In the Matter of)
)
PACIFIC GAS AND ELECTRIC COMPANY)
)
(Diablo Canyon Nuclear Power)
Plant, Units 1 and 2)

TESTIMONY OF DR. ENRIQUE LUCO

Comments by

In compliance with the order of the Atomic Safety and Licensing Appeal Board (August 7, 1980, ALAB-640), I have reviewed the testimony offered by the parties and have considered the questions raised by the Board. My comments to the first six questions are included herewith.

Figure 5-1
(LUCC)

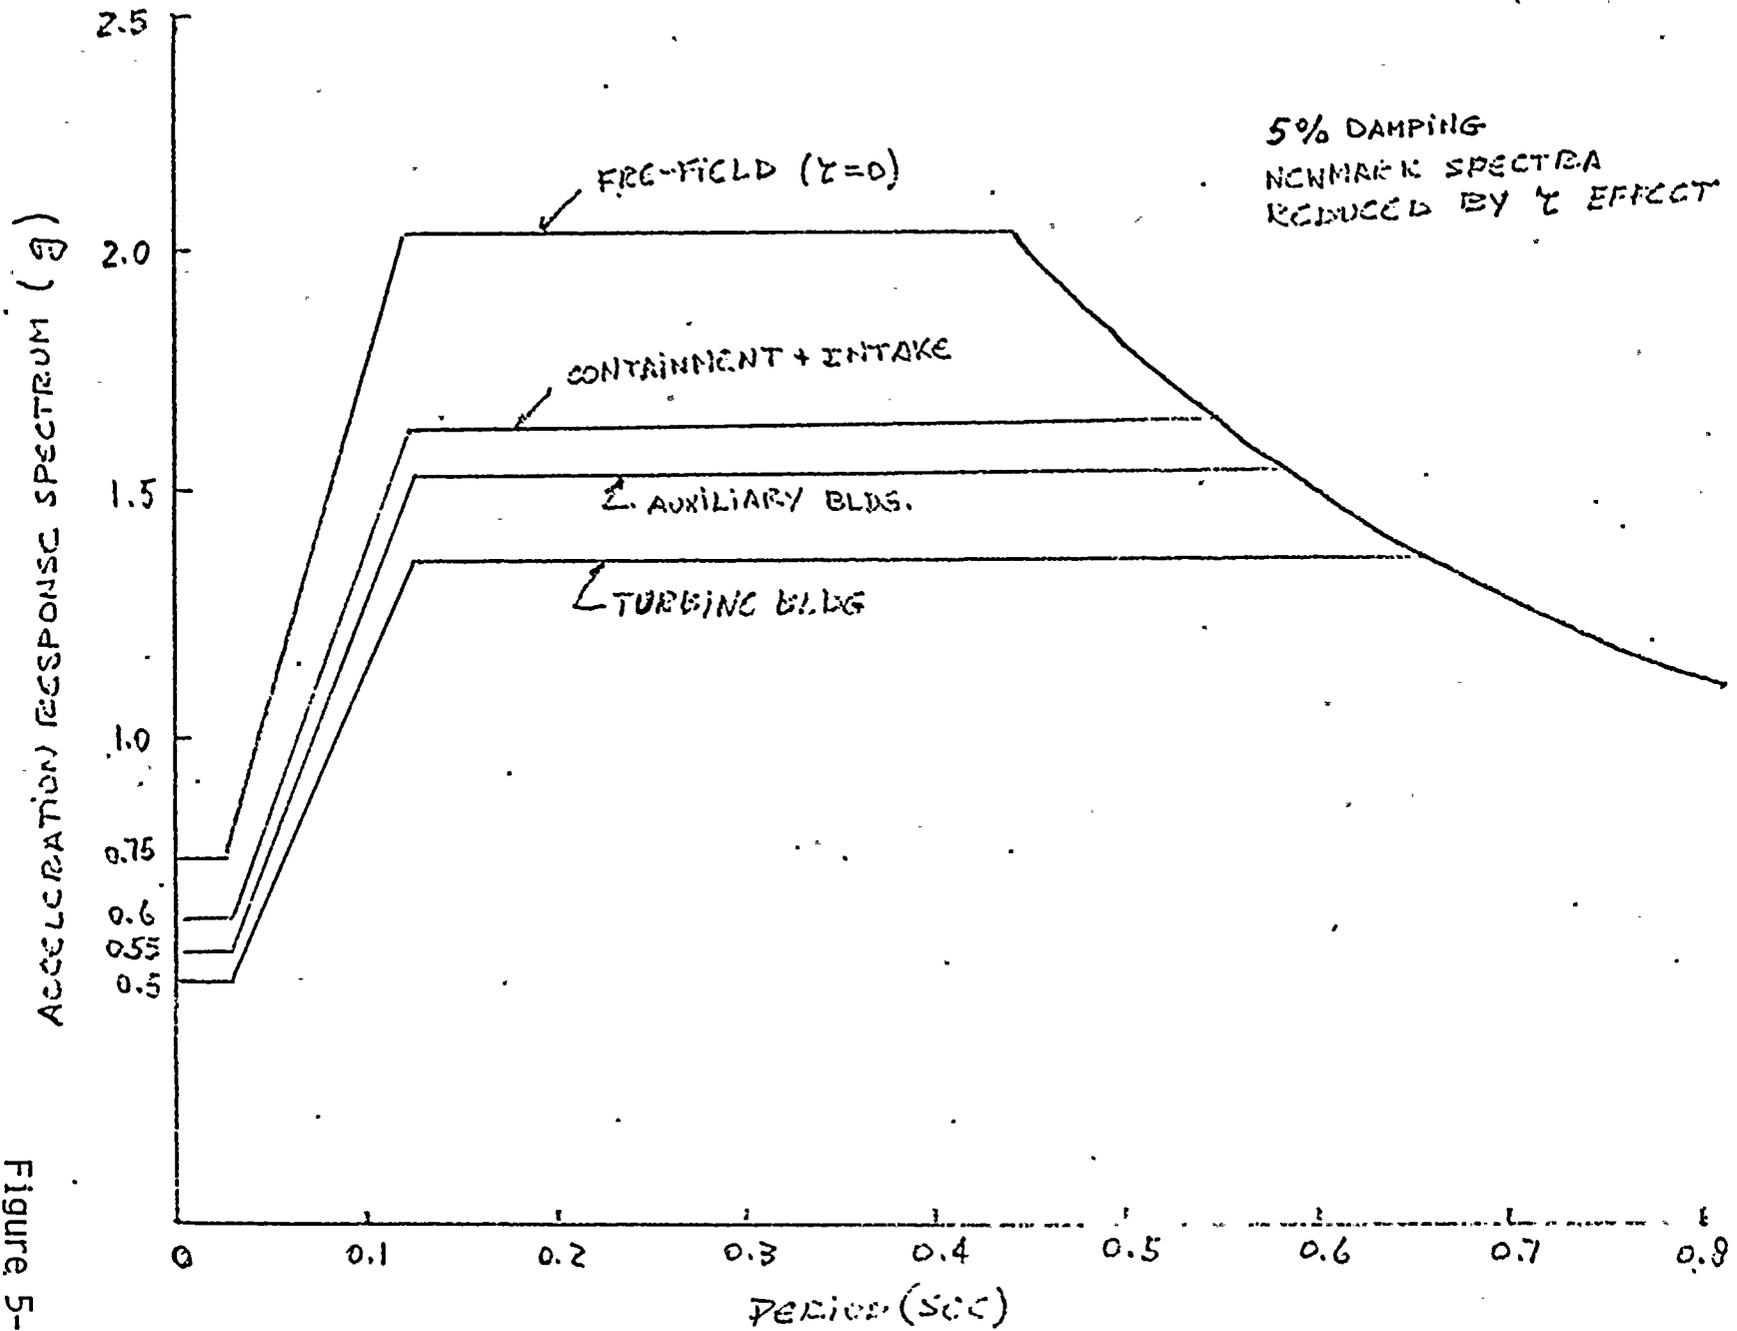
1. The Newmark free-field horizontal design spectrum has been considerably reduced for periods shorter than 0.5 sec (frequencies higher than 2 Hz) by use of the so-called tau effect. The nature of the reductions is shown in Fig. 5-1 (Figs. 3-5, 4-5, 4-6 and 4-7, Seismic Evaluation for Postulated 7.5M Hosgri Earthquake, P.G. and E., Vol. I). Reductions of this magnitude require detailed justification.

It seems, then, that the two rational bases for the tau effect (nonvertically incident waves and incoherence) are not of the magnitude required to justify the reductions of the design spectrum for Diablo Canyon shown in Fig. 5-1.

Figure 5-2 (Lucc

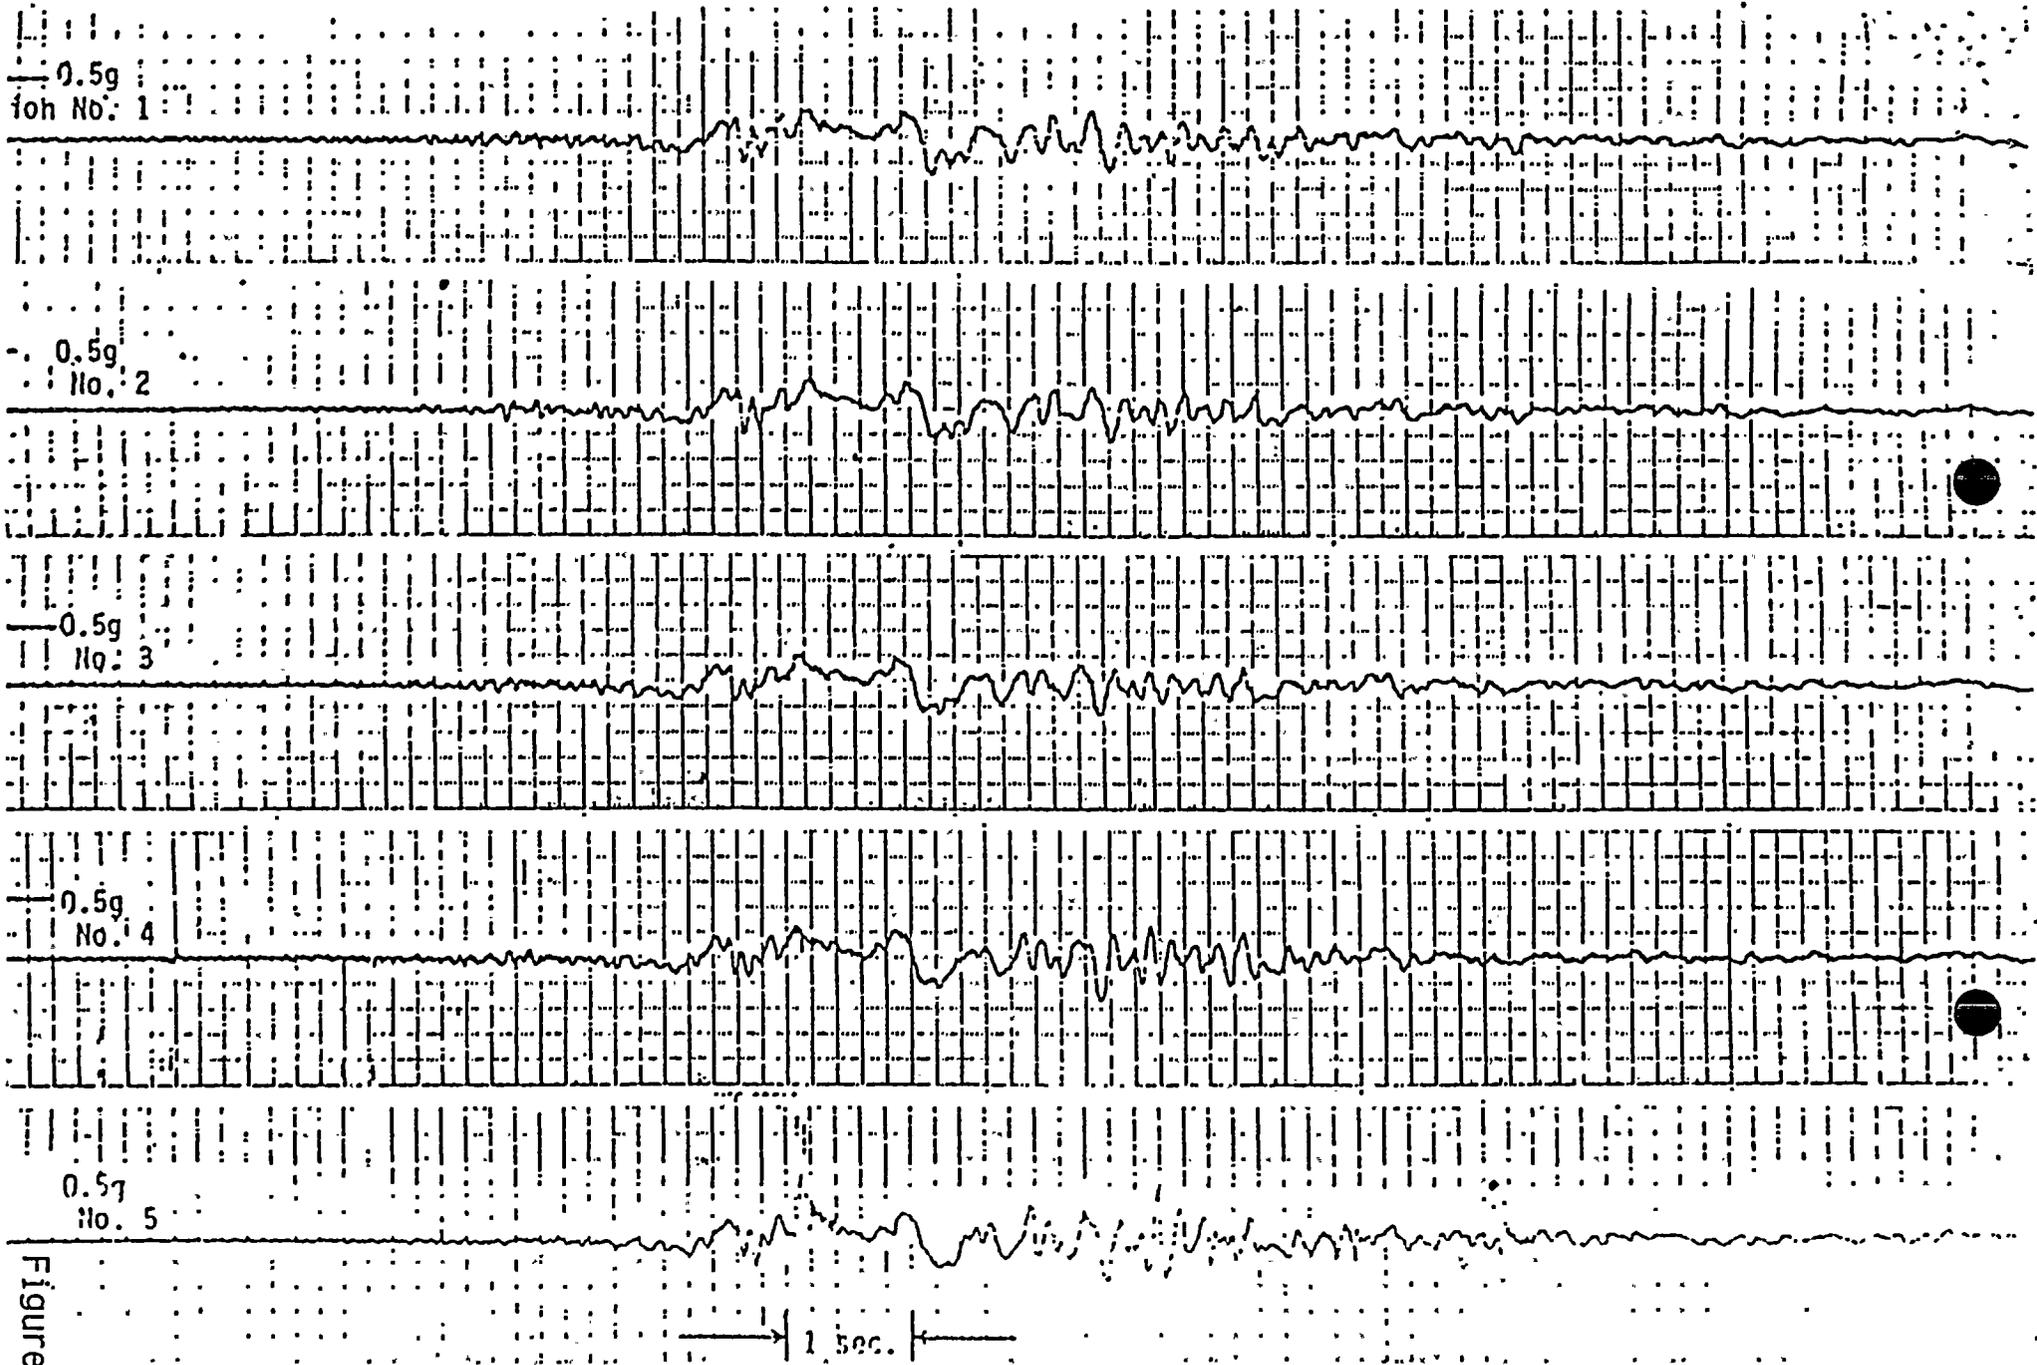
During the Imperial Valley earthquake strong motion records were obtained in a linear array of five instruments (Bycroft, El Centro California Differential Ground Motion Array, USGS Open File Report 80-919, 1980). The array is approximately 3 km from the Imperial Fault. Stations 2, 3, 4 and 5 are at distances of 60, 180, 420 and 700 ft from station 1. The acceleration time histories recorded in the E-W direction are shown in Fig. 5-2. Since the timing system failed, the time axis shown in the figure does not correspond to absolute or relative time. The similarity of the records (at least to the naked eye) at stations 1, 2 and 3 is striking. Some slight differences between the records at stations 4 and 1 (separated by 420 ft) can be observed. Although more detailed analysis of these records is necessary, it is possible to say that the motion of points separated by distances of 180 ft is coherent at least up to frequencies of 5 Hz.

Figure 6-1
(Luco)

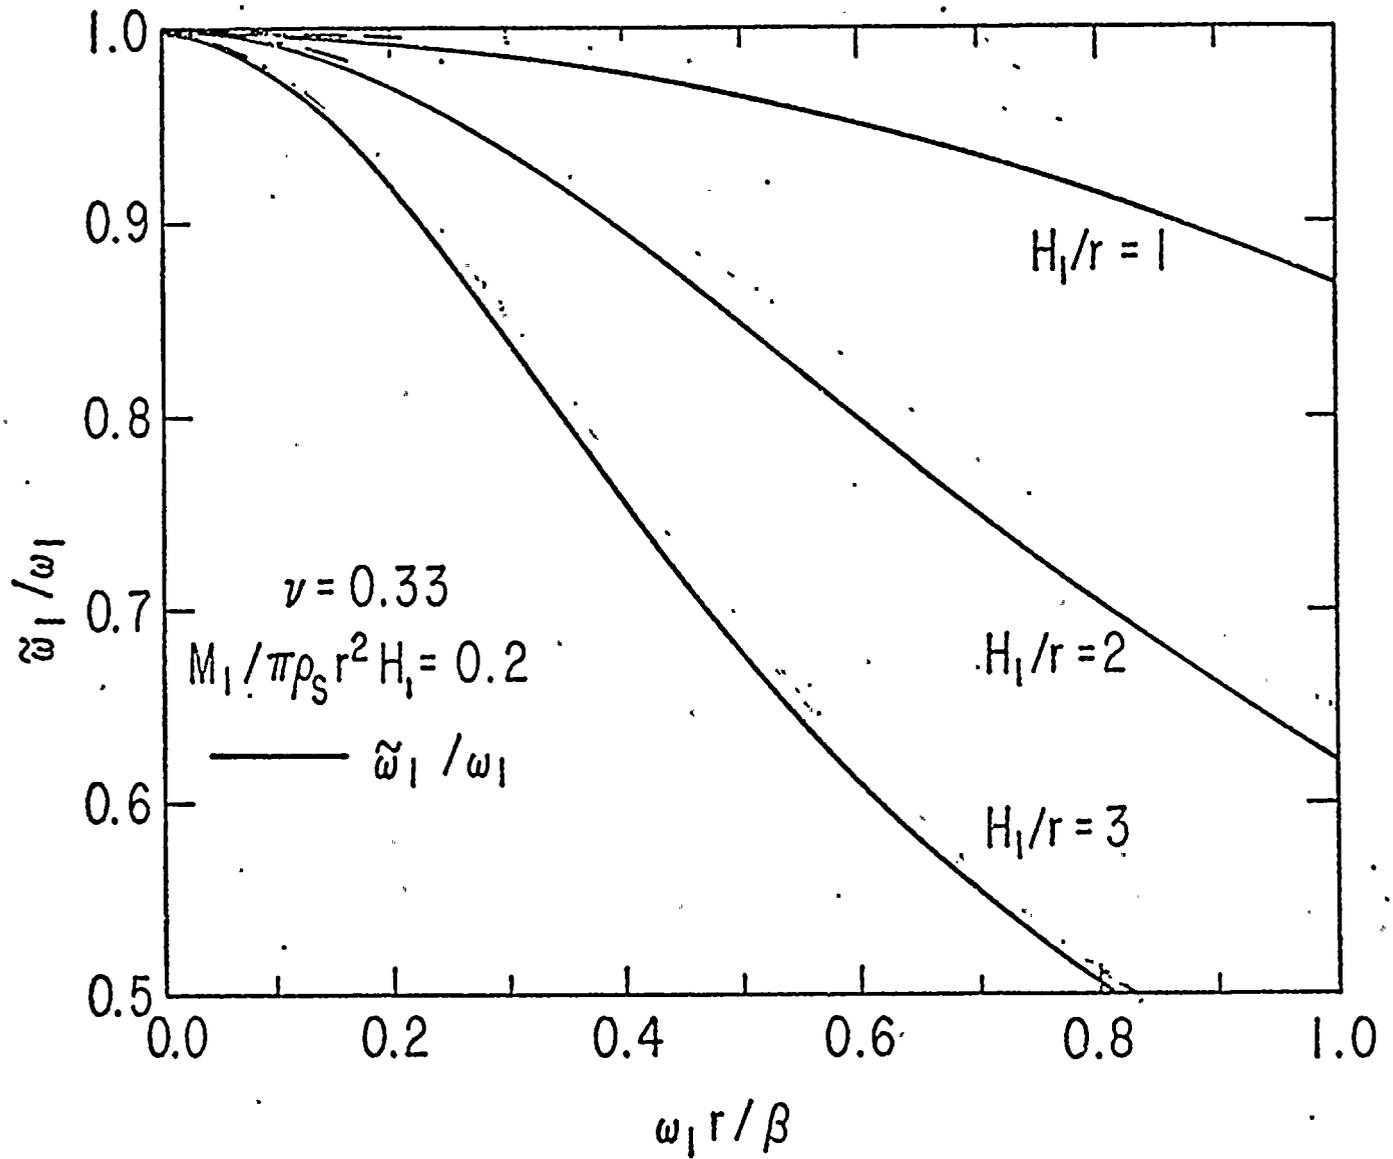
and ~ 2.0 , respectively. Fig. 6-1 indicates that as a result of interaction, the frequency of the system will be approximately 18 percent lower than the fixed-base frequency.

Figure 6-2
(Luco)

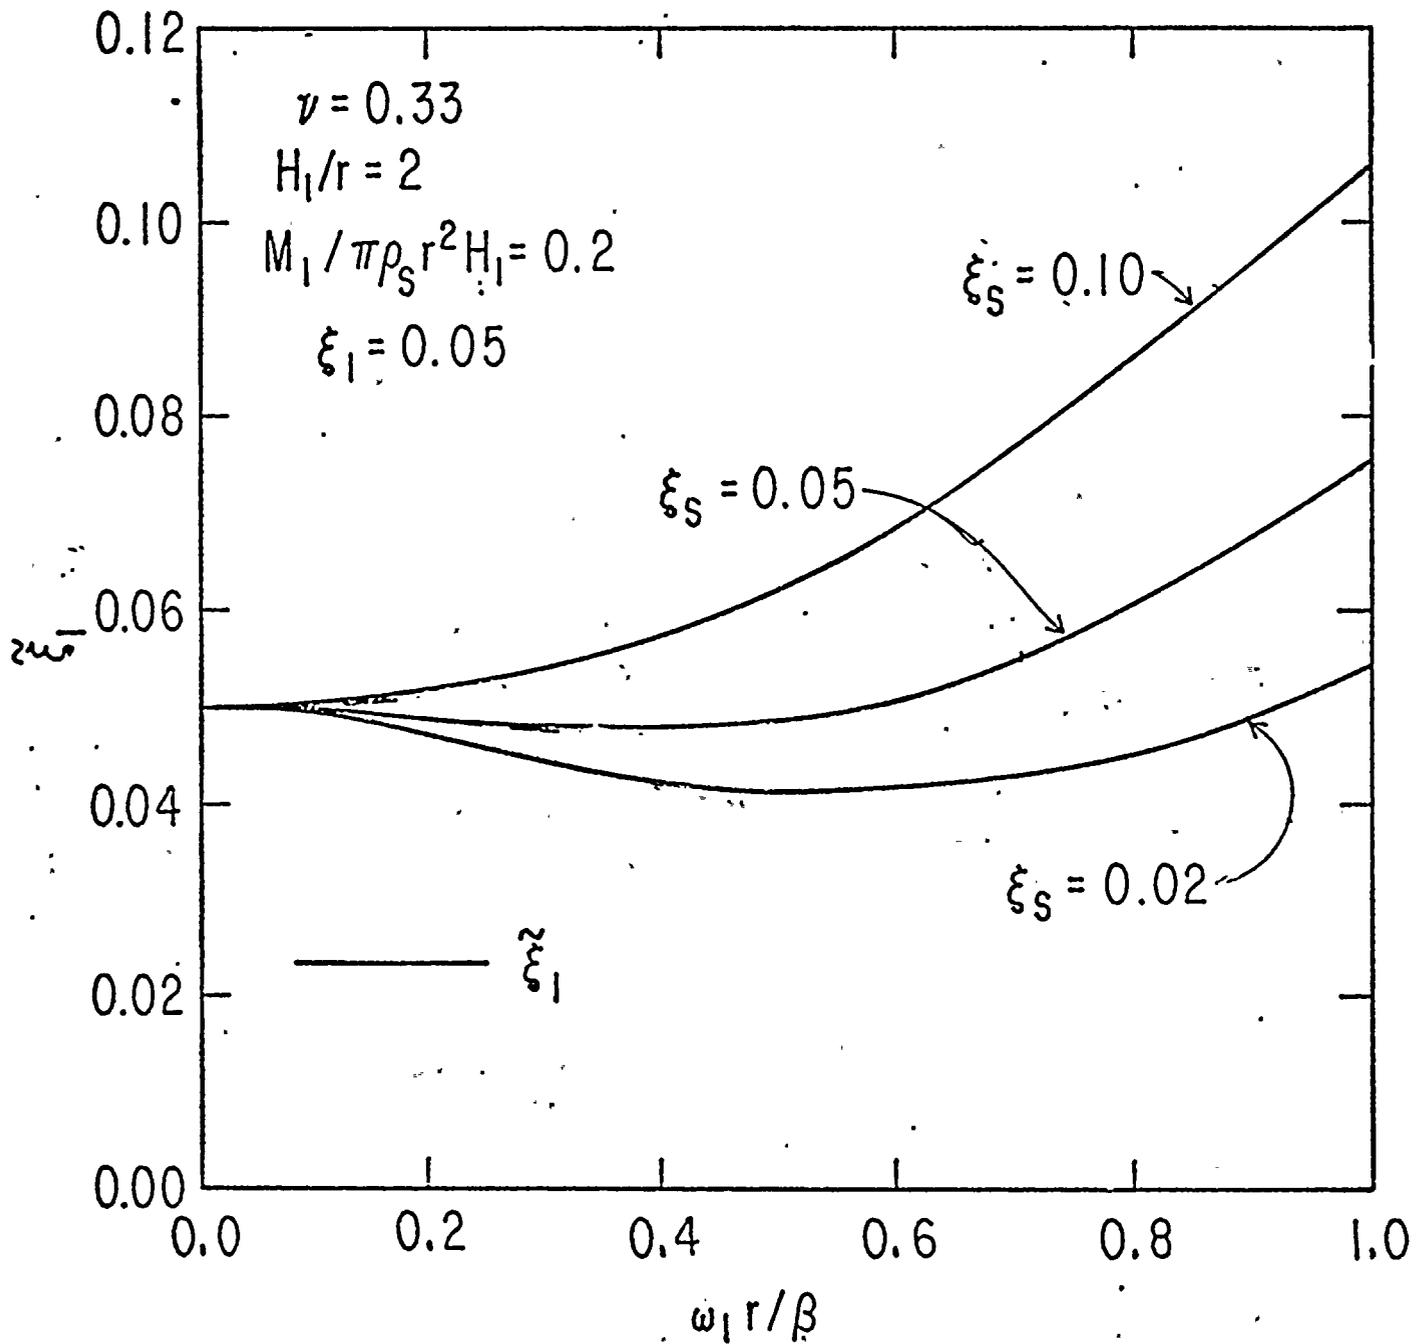
A second important effect of interaction is the modification of the damping. This modification depends on the three parameters indicated above, on the damping of the superstructure (ξ_1) and on the material damping in the soil or rock (ξ_s). Fig. 6-2 illustrates the variation of the system damping $\tilde{\xi}_1$ (with interaction) with the relative stiffness $\omega_1 r/\beta$ and with the damping in the soil ξ_s . Fig. 6-2 has been drawn for a damping of five percent in the structure ($\xi_1 = 0.05$). Since Diablo Canyon is supported on rock, ξ_s will have a value of the order of 3% and Fig. 6-2 indicates that the system damping would be similar to the damping in the structure. For Diablo Canyon a damping in the structure of 7% has been used. In this case, the system damping will be lower ($\sim 6\%$).

Figure 6-3 (LUCCO)
FIGURE NO. 3B-C

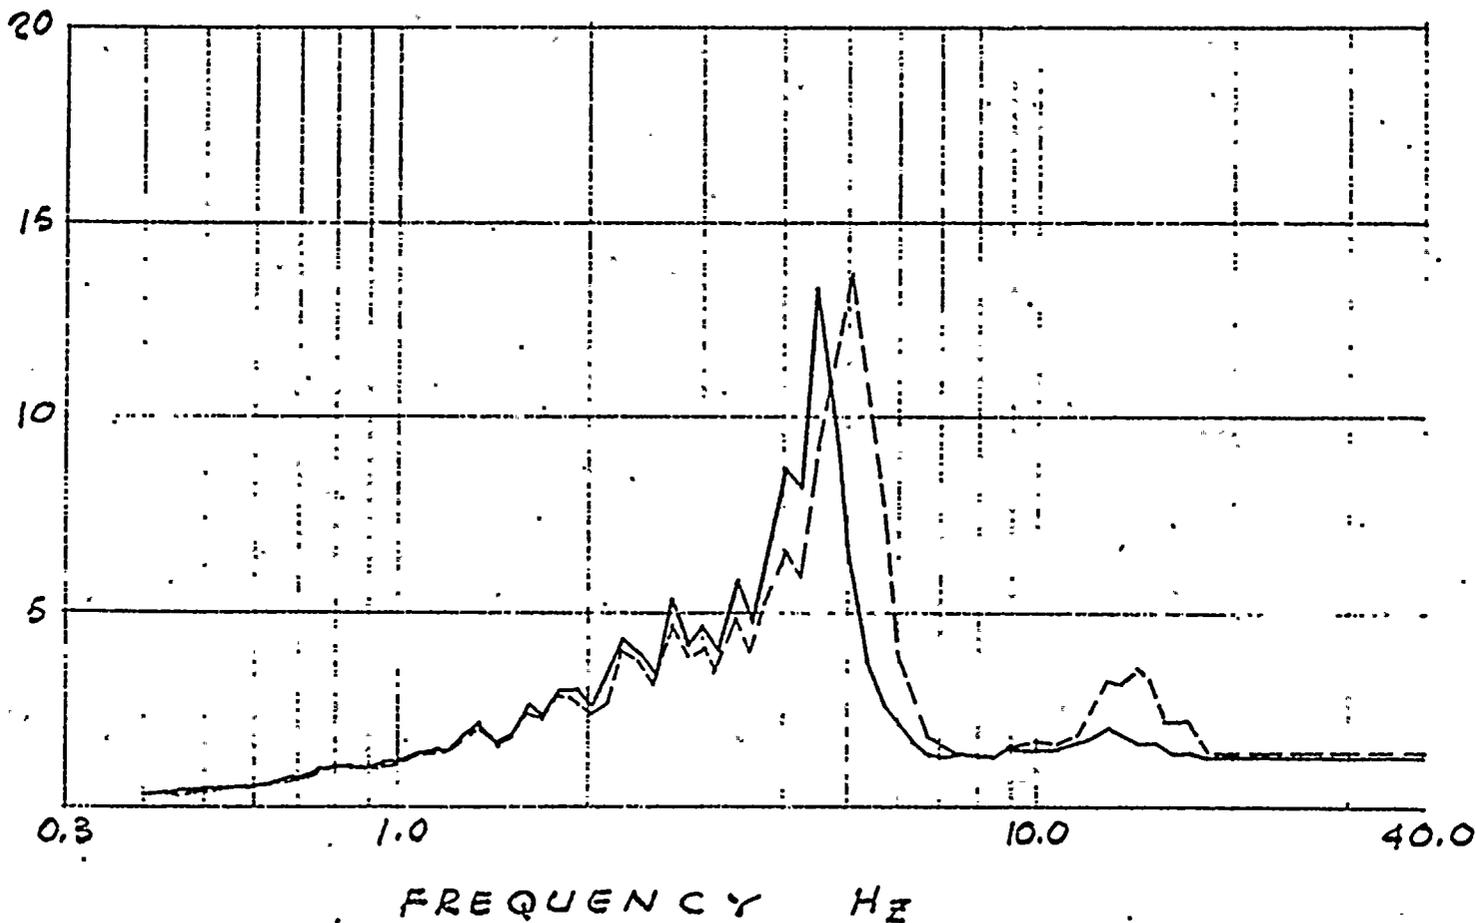
The effect of soil-structure interaction on the translational response at foundation level is similar to the effects already described for points at higher elevations, i.e. amplification of low frequency components and reduction of high frequency components. One difference, at foundation level, is that at high frequencies, i.e. where the spectrum tends to the peak acceleration, the motion may be slightly higher or lower than in the free-field. This occurs for surface or shallowly embedded foundations. For deeply embedded foundations, the peak acceleration is typically considerably lower than on the ground surface. These effects on the translational response at the base of the structure are illustrated in Fig. 6-4 taken from Seed's testimony (Fig. VI-1). For frequencies lower than the fundamental system frequency (~4 Hz), the response with interaction is equal or slightly above the results for a rigid soil. For frequencies in the range from 4 to 20 Hz, the response with interaction is lower than in the free-field. Finally, for frequencies above 20 Hz the response with interaction is essentially equal to the free-field motion.

When soil-structure interaction is considered rocking of the foundation occurs. One of the effects of rocking is to induce vertical components of motion along the perimeter of the foundation. These vertical components of motion are not included in a rigid soil analysis. Also, if the structure is not symmetric, or, if the seismic excitation corresponds to nonvertically incident waves, torsional response is induced.
